Consolidated Edison Company of New York, Inc.  
Indian Point Station  
Broadway & Bleakley Avenue  
Buchanan, NY 10511  
Telephone (914) 737-8116

Re: Indian Point Unit No. 2  
Docket No. 50-247

SUBJECT: ATWS Mitigation System Actuation Circuitry ("AMSAC")

Response to NRC's SER  
Plant Specific AMSAC Design

FIGURE I-1

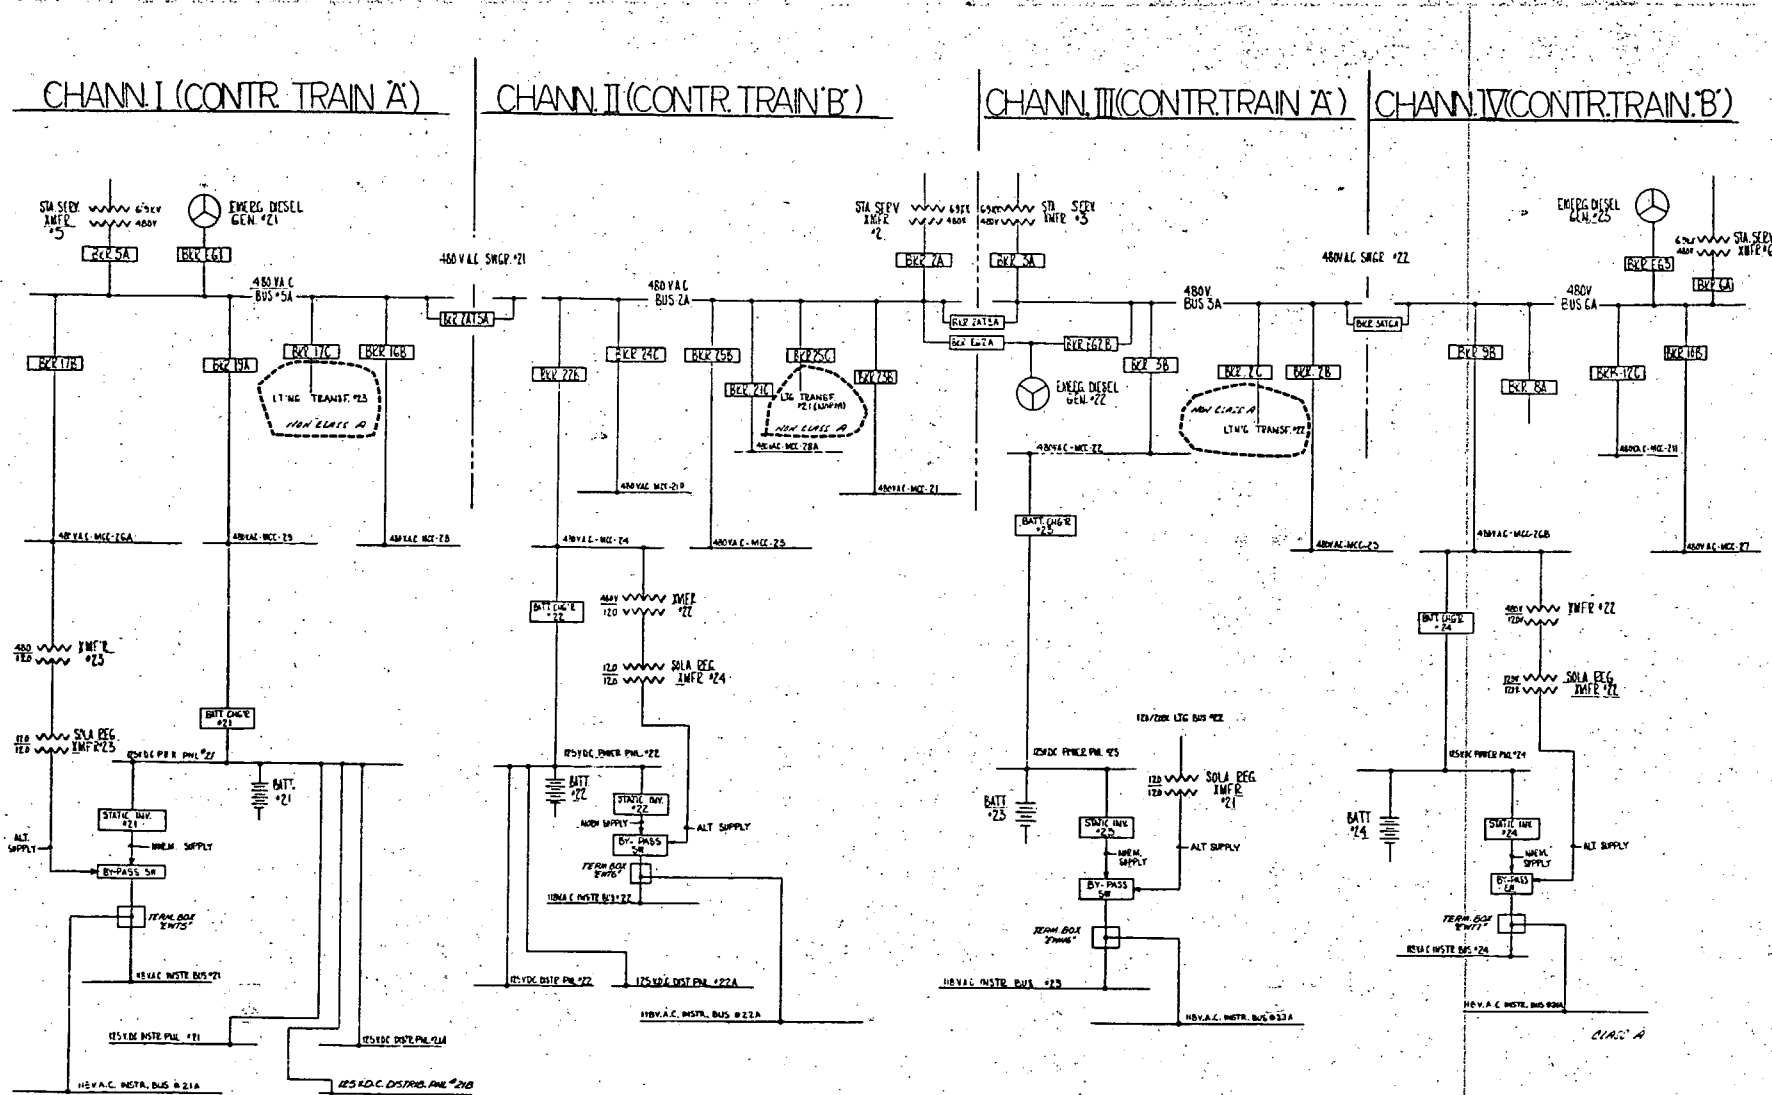
Power for AMSAC, a non-safety grade system, will be derived from the class 1E 125 VDC distribution panels Nos. 23 and 24. These 1E panels are safety-related battery-backed and capable of being

operated from either an off-site power source or on-site emergency diesel generators. Existing Reactor Protection System ("RPS") logic is supplied from 125 VDC distribution Panels 21 and 22 (Train A and Train B respectively) such that AMSAC and RPS logics will utilize power supplies independent of each other.

Battery Charger No. 23 (associated with distribution panel No. 23) is connected to Motor Control Center ("MCC") No. 22 and is stripped in preparation for diesel loading. Battery Charger No. 24 (associated with distribution panel No. 24) is connected to MCC No. 26B and is not stripped in preparation for diesel loading. Therefore, during the transition from station or grid service to emergency diesel generator service, distribution panel No. 23 is stripped but distribution panel No. 24 is not stripped. Since batteries can supply power to the DC bus for two hours without interruption, and battery chargers can be used to charge the batteries, AMSAC power will not be interrupted.

The attached Figure I-1 is a copy of IP-2 Updated FSAR Figure 8.2-17 and is a one-line diagram depicting bus arrangement from the 480 VAC buses down to the 125 VDC and 118 VAC buses for all four channels (trains) of power supply. This figure shows the line-up to 125 VDC distribution panels Nos. 23 and 24.

FIGURE 11-1

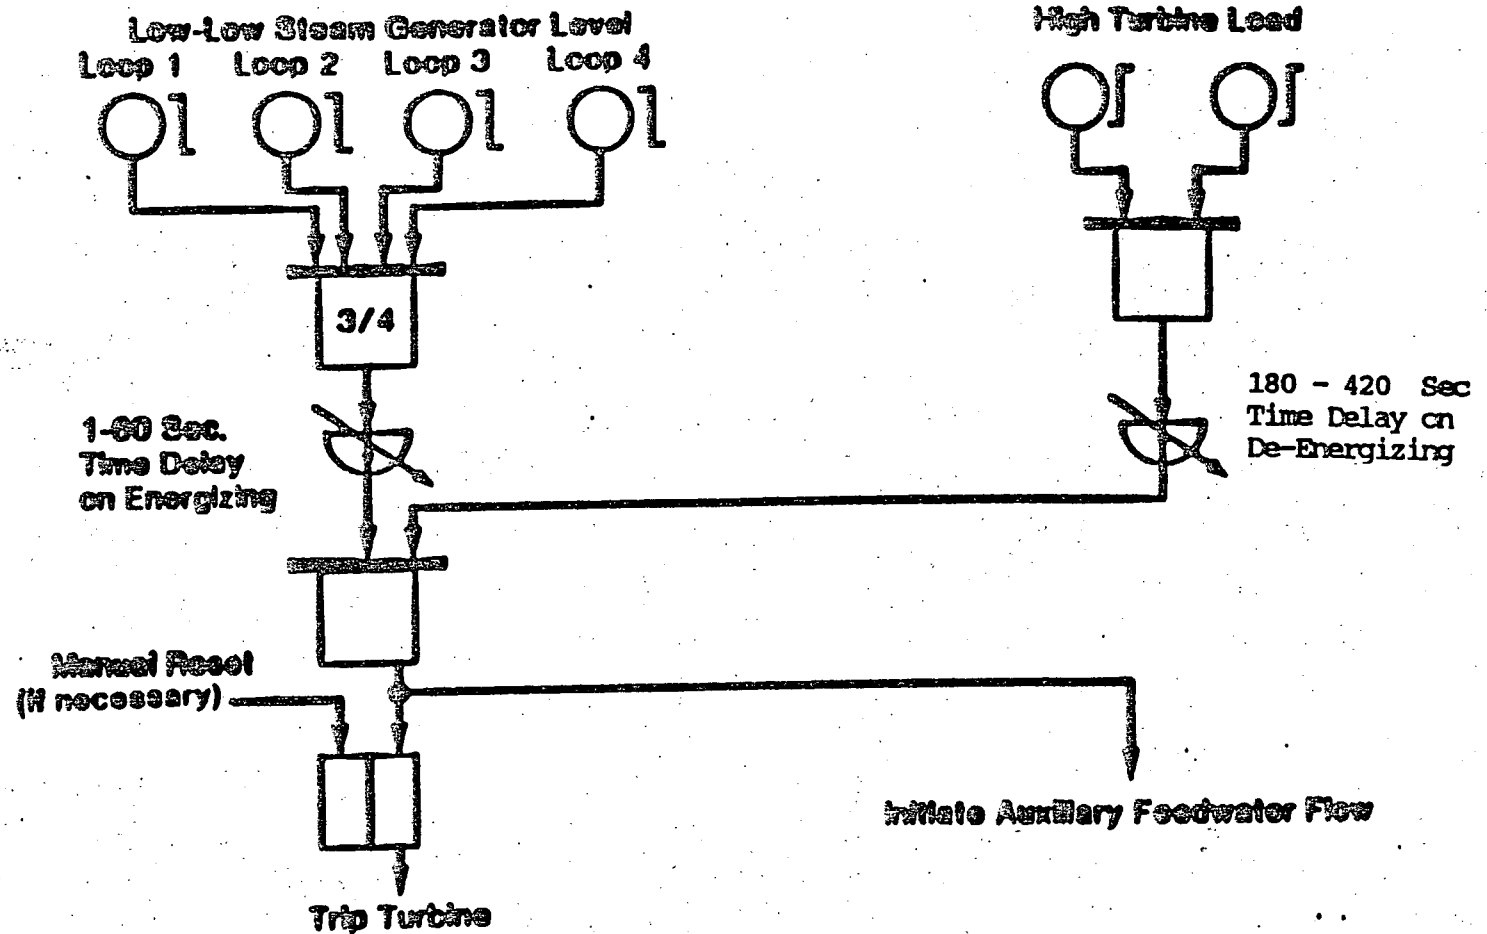
IP-2's AMSAC design is based on a modified Logic 1 option "AMSAC Actuation on Low Steam Generator Water Level" as described in Westinghouse WCAP-10858P-A, Revision 1. The modification to the generic design involves the deletion of the C-20 permissive and time delay circuits.

The C-20 permissive, as described in WCAP-10858P-A, Revision 1, is not required in the IP-2 specific design. AMSAC will be armed during power operation except for maintenance and testing. Alarms associated with an expected AMSAC actuation which occur during a planned shutdown will be treated in the same manner as steam generator low-level alarms.

The plant specific AMSAC design for the Indian Point Unit No. 2 ("IP-2") AMSAC is based on a modified version of generic logic 1 option (Steam Generator Low Level Actuation) described in Westinghouse WCAP-10858P-A Figure 1-3, which is attached (Figure II-1).

FIGURE II-3

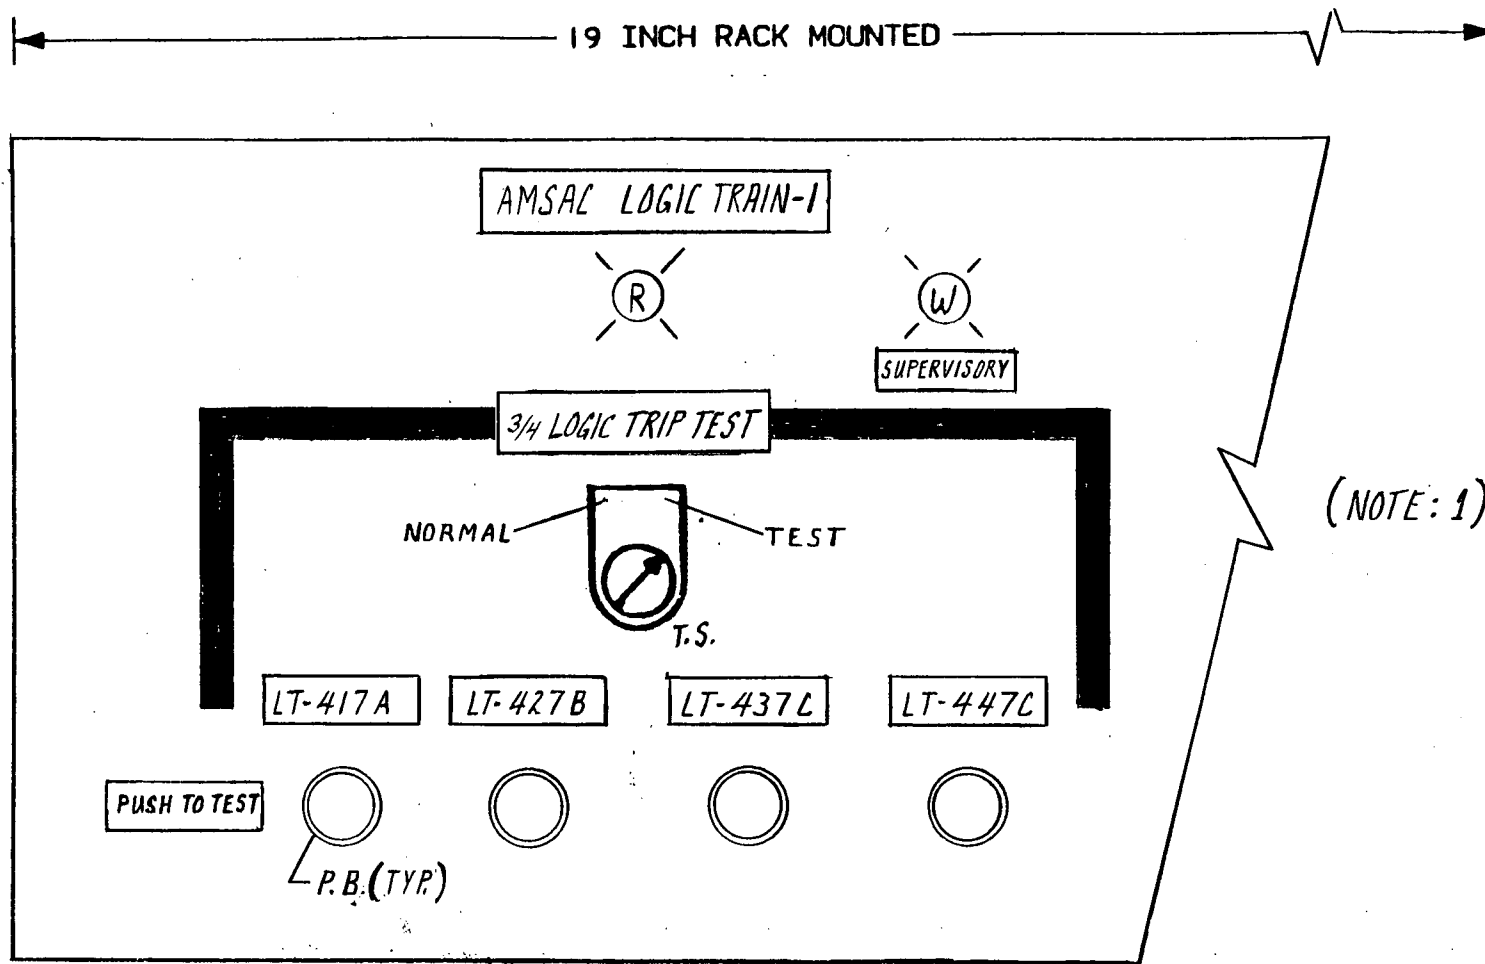
The AMSAC design will provide for manually bypassing the mitigating function of either of the two logic circuits for testing and maintenance. For either AMSAC logic circuit, a two-position selector switch and push buttons (providing a push-to-test feature) will be provided. For each of the four analog input channels to the AMSAC logic a two-position selector switch for channel testing will be provided. When any one of these switches is placed in the off-normal test (bypass/maintenance) position an audible annunciation window tile will be lit indicating that the respective logic circuit is bypassed for testing.

The bypass/maintenance condition will be continuously indicated to the operator in the control room by an annunciator window tile located above the flight panel whenever any one of the two position switches are turned to the bypass/maintenance position.

The attached logic diagram SK-15805-12 (Figure II-2) and the Test Panel assembly diagram SK-15805-22 (Figure II-3) depict our proposed implementation of AMSAC. We wish to point out that as work progresses the design may be revised slightly. The final design modification package will be available onsite prior to installation for review.

DWG. NO. SK-15805-12

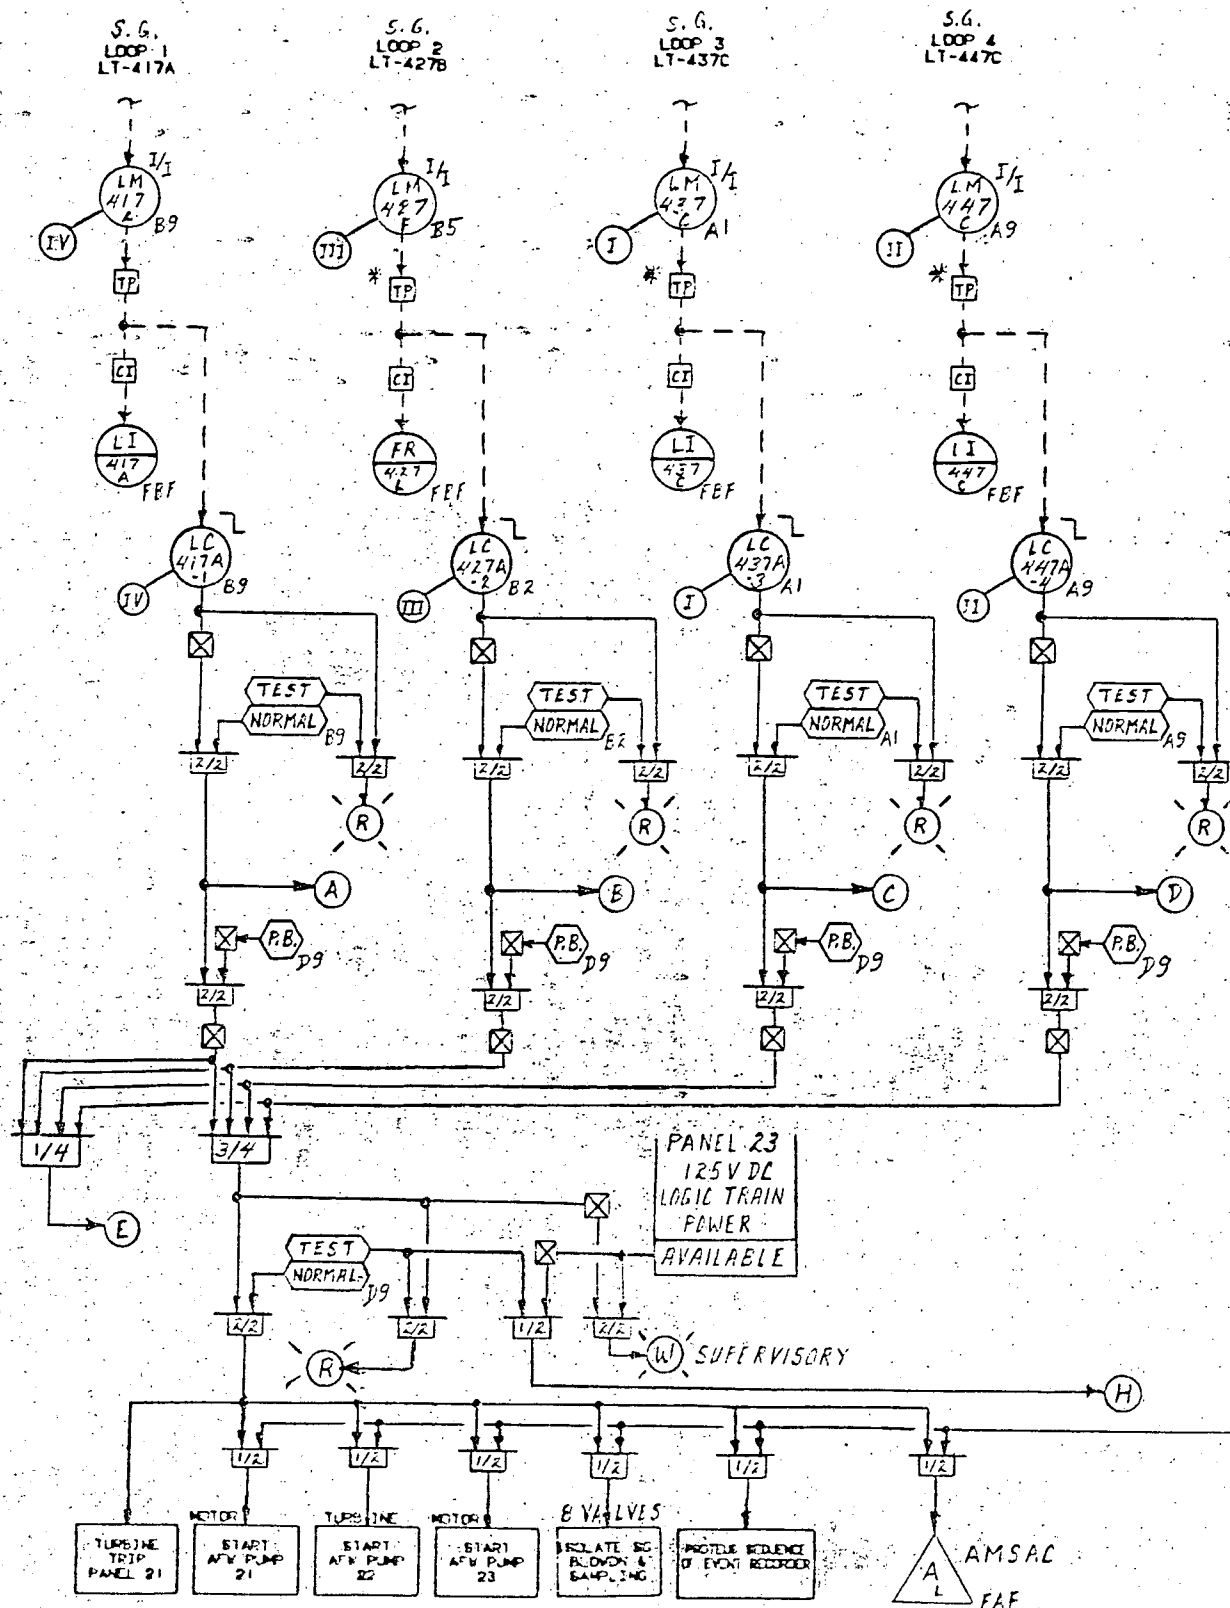
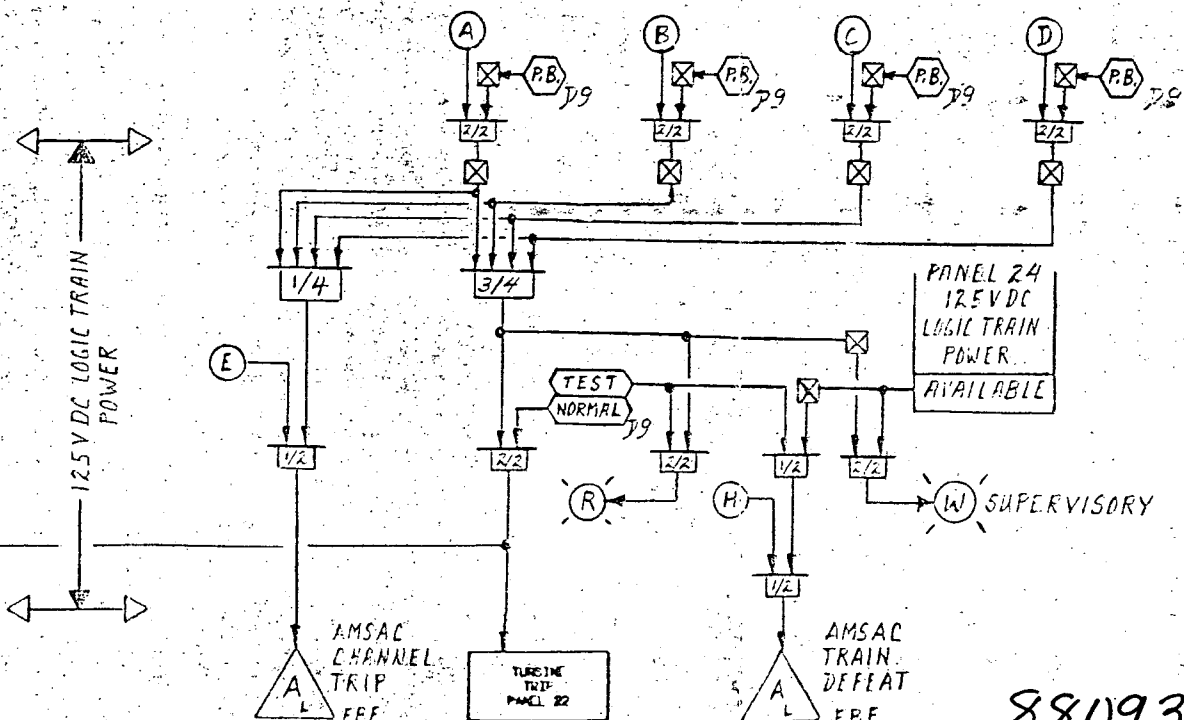
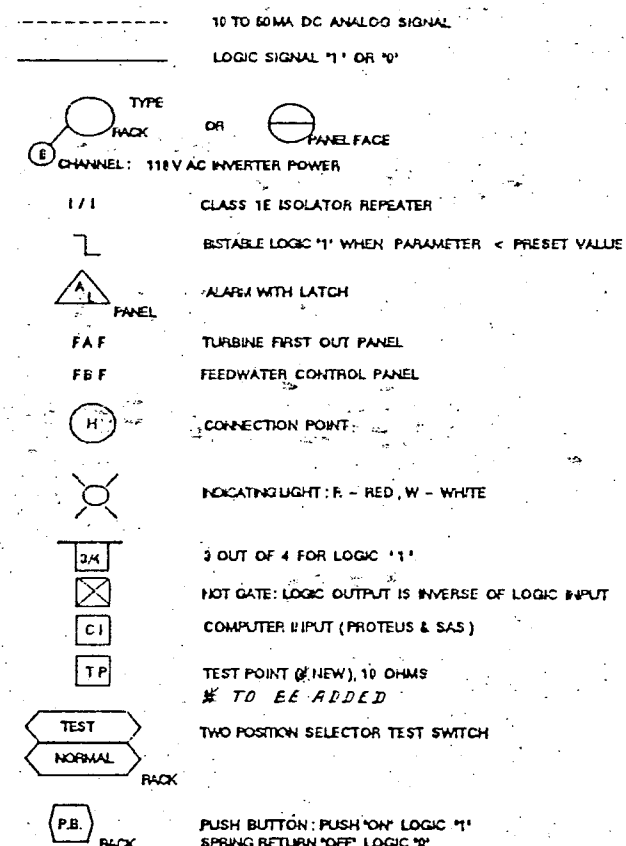
1. AMSAC initiation will be generated by steam generator very-low water level signals from existing sensor/transmitter units. The IP-2 design consists of one existing narrow-range level transmitter signal from each steam generator as input to AMSAC; a coincidence of 3 out of 4 signals is required to actuate AMSAC.
2. An AMSAC signal will result in a turbine trip, start-up of the three auxiliary feedwater pumps, isolation of steam generator blowdown and closure of sample valves.
3. Completion of the mitigating action, once initiated, will be consistent with existing turbine trip, auxiliary feedwater, steam generator blowdown and sample valve isolation circuitry.

AMSAC logic input (analog) signals will be normally energized; de-energized to trip. AMSAC logic signals will be normally de-energized; energized to trip. This is diverse from existing reactor protection logic equipment. Dual AMSAC logic will maximize system availability in the event a single DC bus is lost. Each analog level channel selected for AMSAC input will be powered from a different instrument bus as follows:
